TRAFFIC IMPACT ASSESSMENT (TIA)

Uniting Shellharbour Stage 1 Residential Detailed Development Application Submission

Reference: 23.457r01v06
Date: May 2025

Re: Uniting Shellharbour - 171 Wattle Road, Shellharbour Modification (DAN0146/2024)
Request for Information

23.457	S455	TX.03

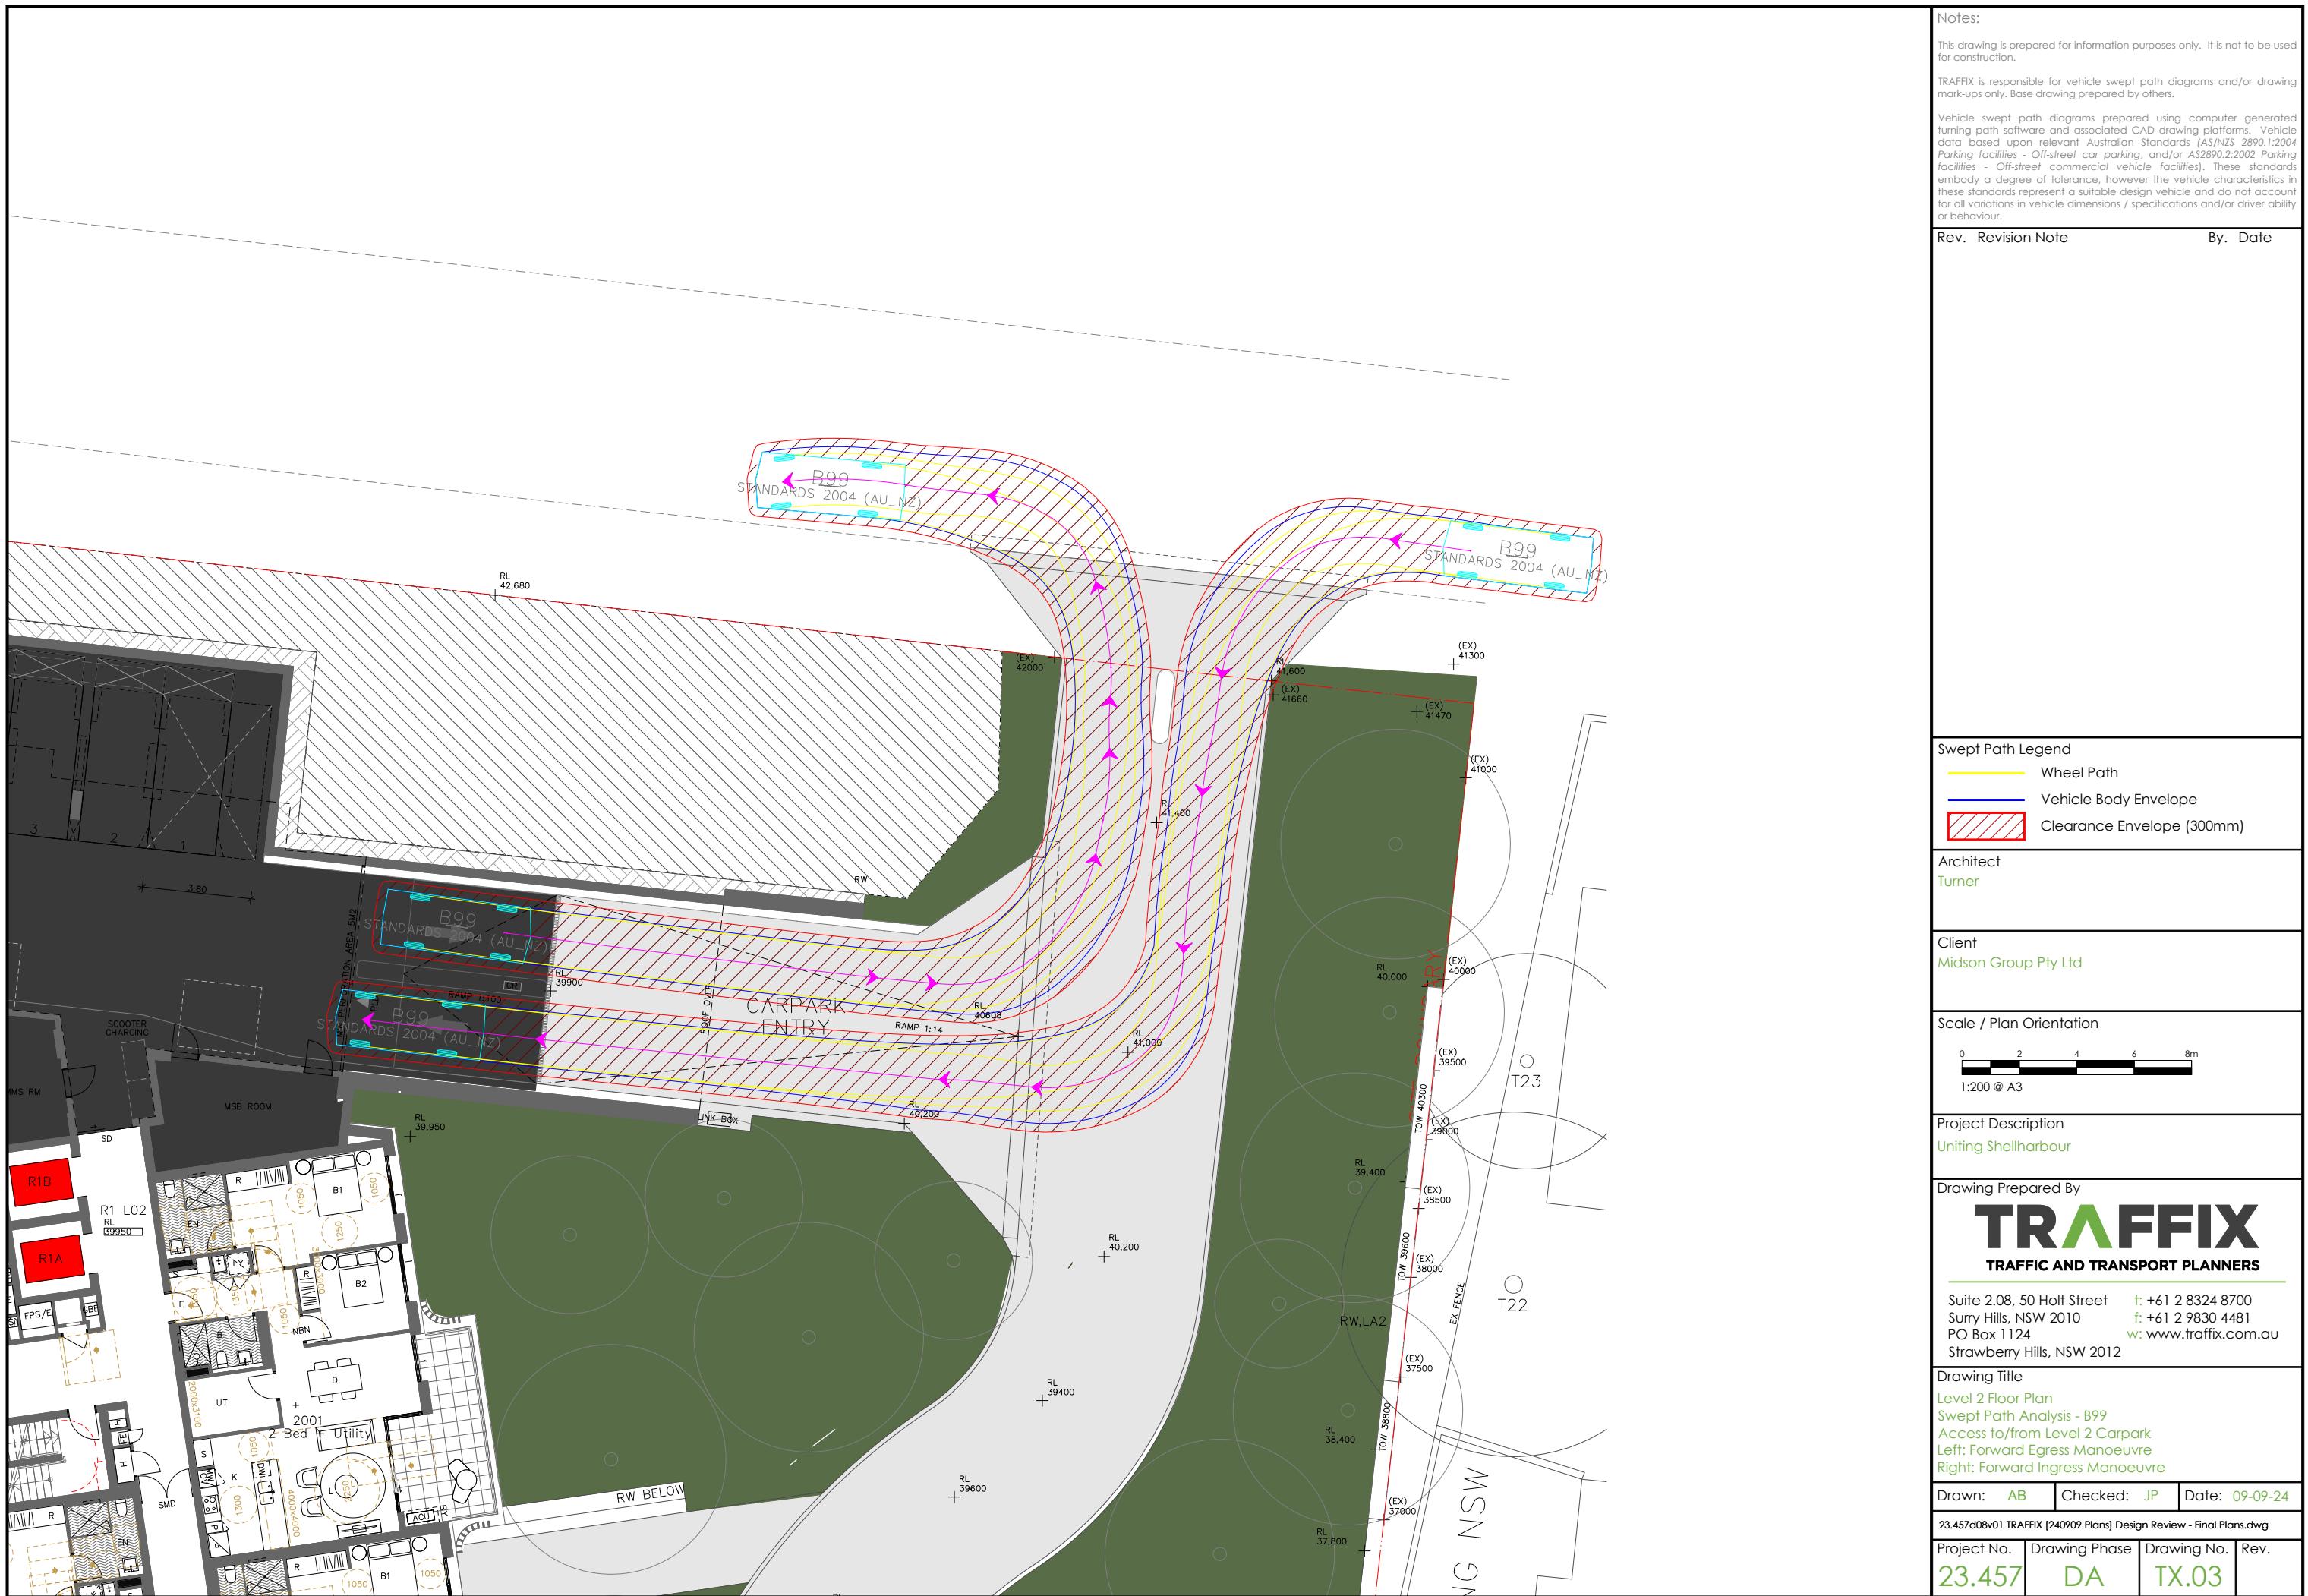
- *Swept paths for the driveway accessing 15 Benson Avenue, Shellharbour City Centre for both B99 vehicles as a design vehicle, and an MRV as a checking vehicle.*

Reference should be made to the swept path analysis provided in **Attachment 2** showing the satisfactory operation of the driveway accessing 15 Benson Avenue.

Signage and Line Marking Plan

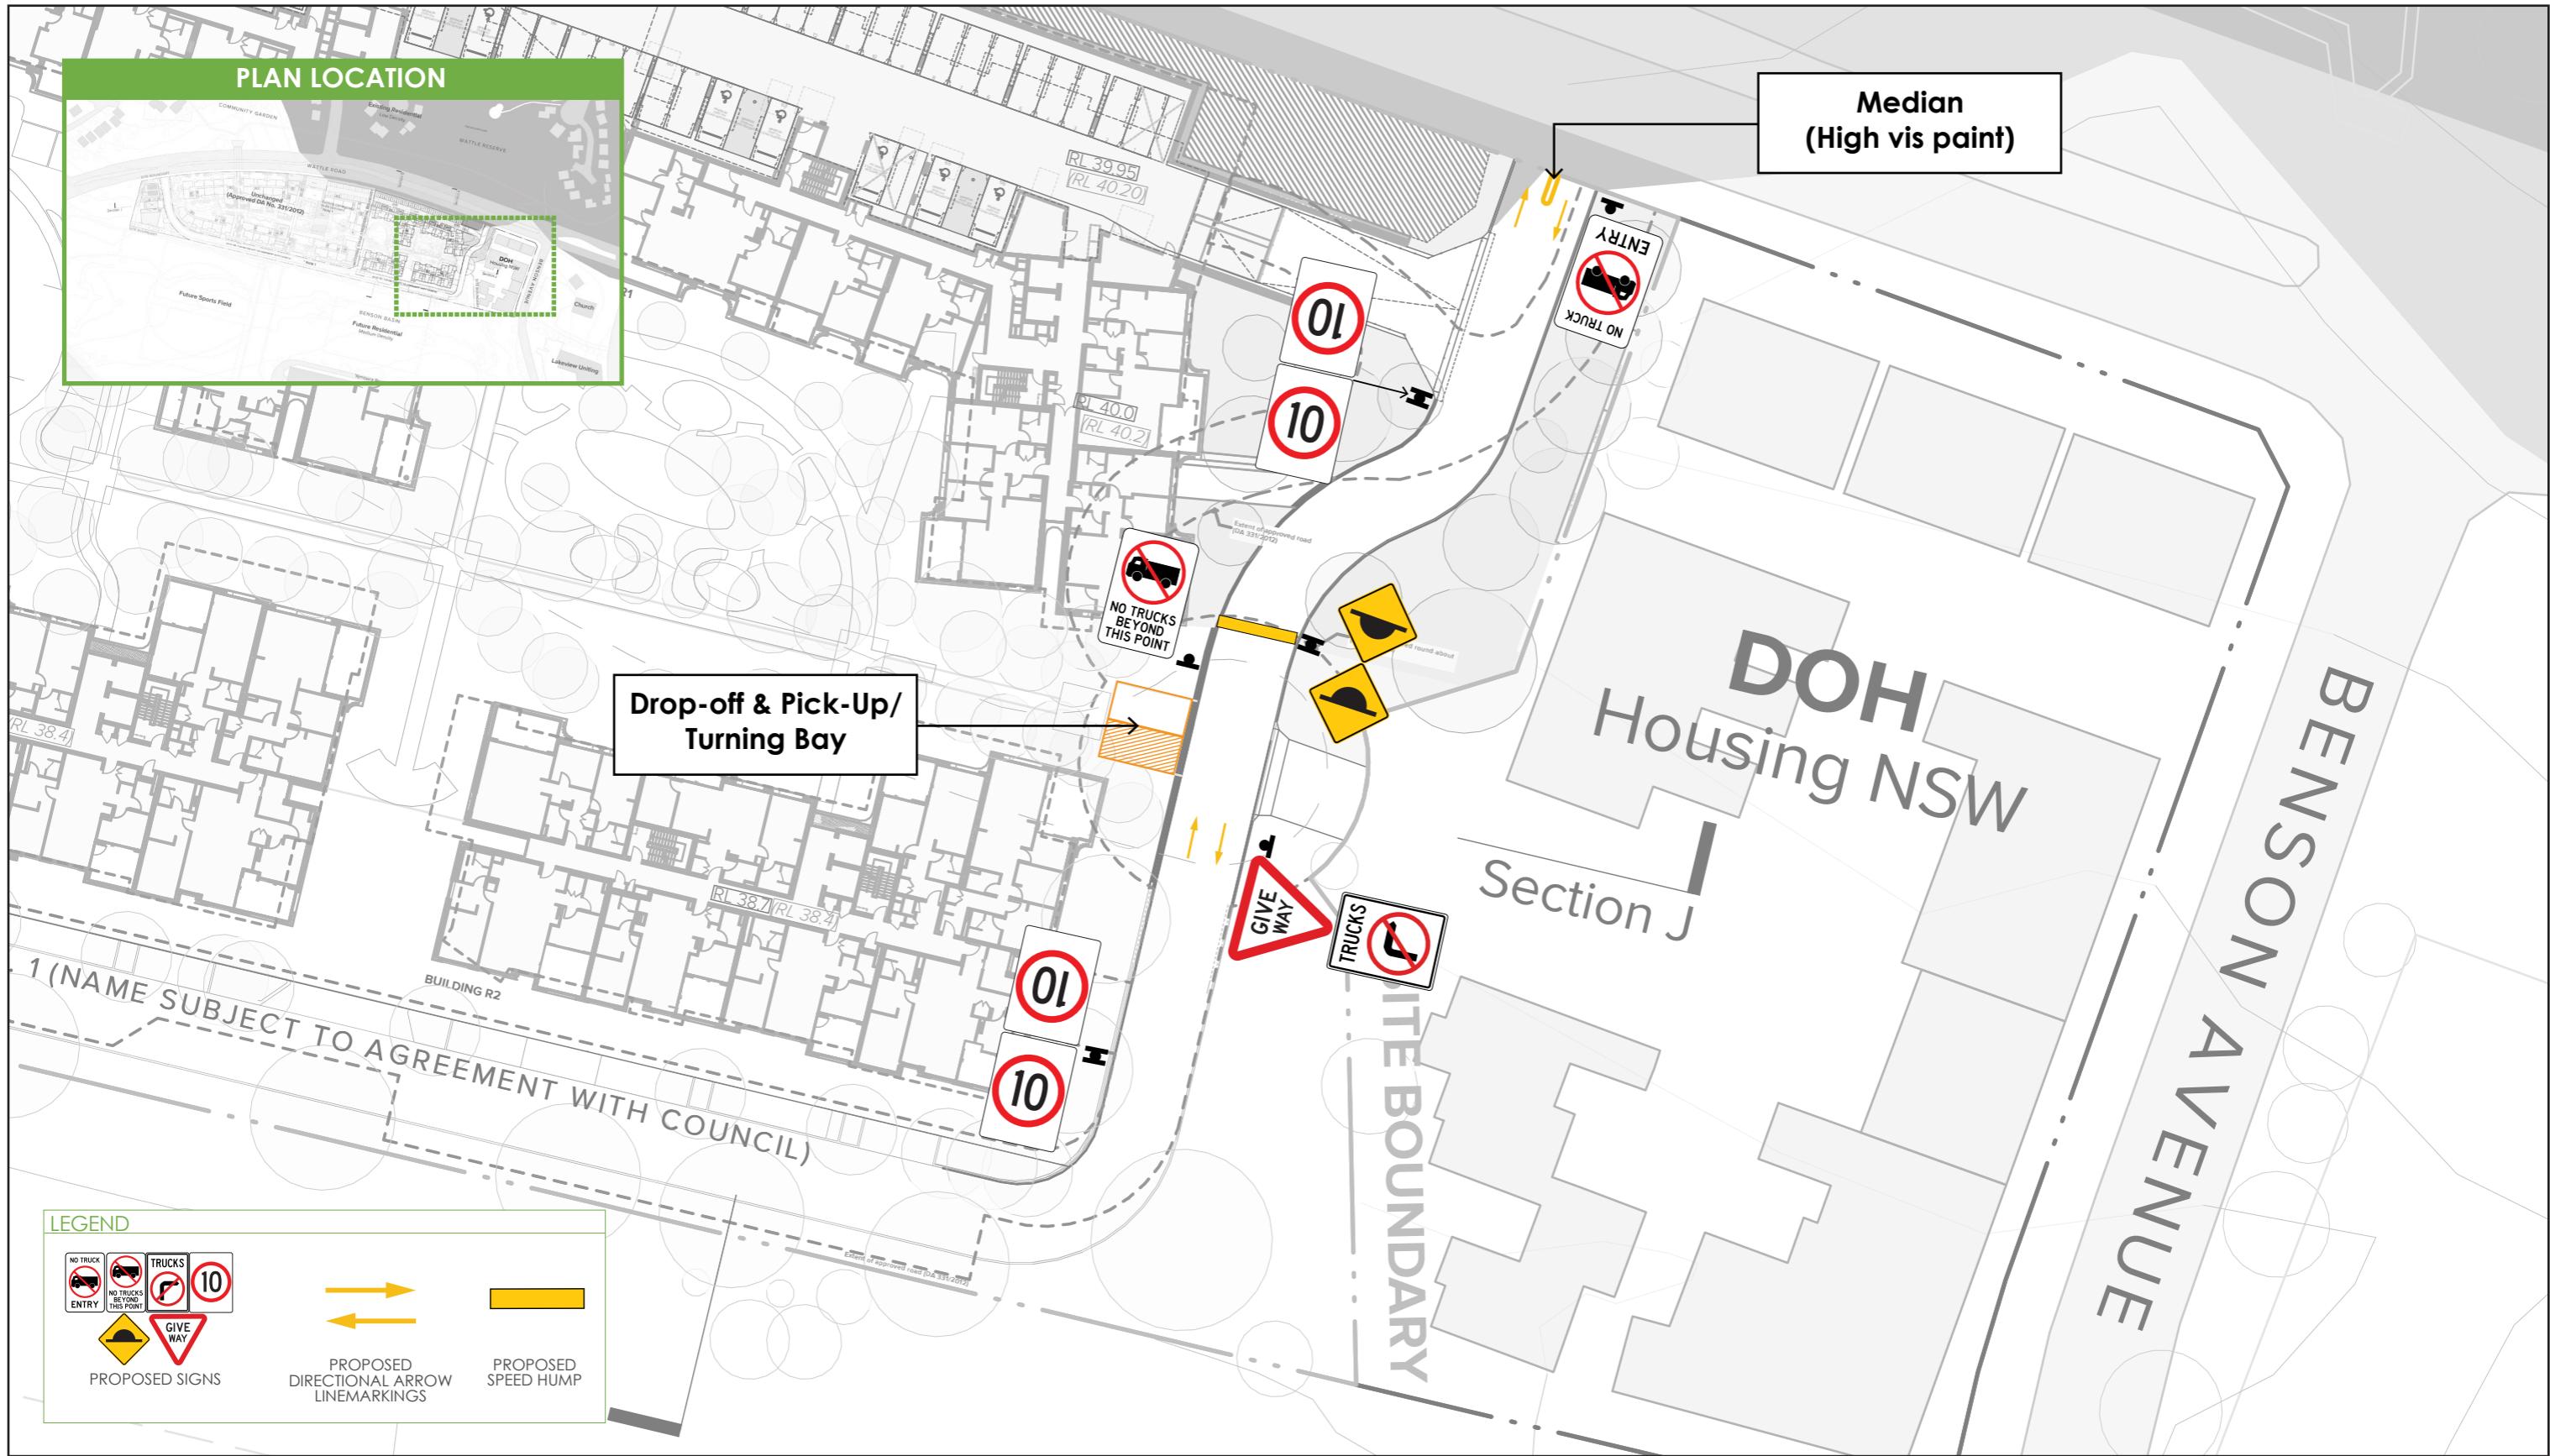
- *Details as to how large vehicles will be prevented from using the southern access (e.g. via design or regulatory controls/signage); and how reverse manoeuvres into Wattle Road will be prevented should a large vehicle disobey any signage - noting that not only service vehicles contracted to the site will be accessing the internal road.*

Heavy vehicles are not permitted to access the subject site via the southern access and this access will be restricted to light vehicles only. Access is to be controlled with signage, LATM treatments and line marking. In particular, a median is provided within the property boundary at the southern access which will prevent trucks and large vehicles from entering via the southern access. The median is proposed to be painted with hi-vis paint as an additional measure to prevent trucks from entering via the southern access. Reference should be made to the signage and line marking plan provided in **Attachment 1**.
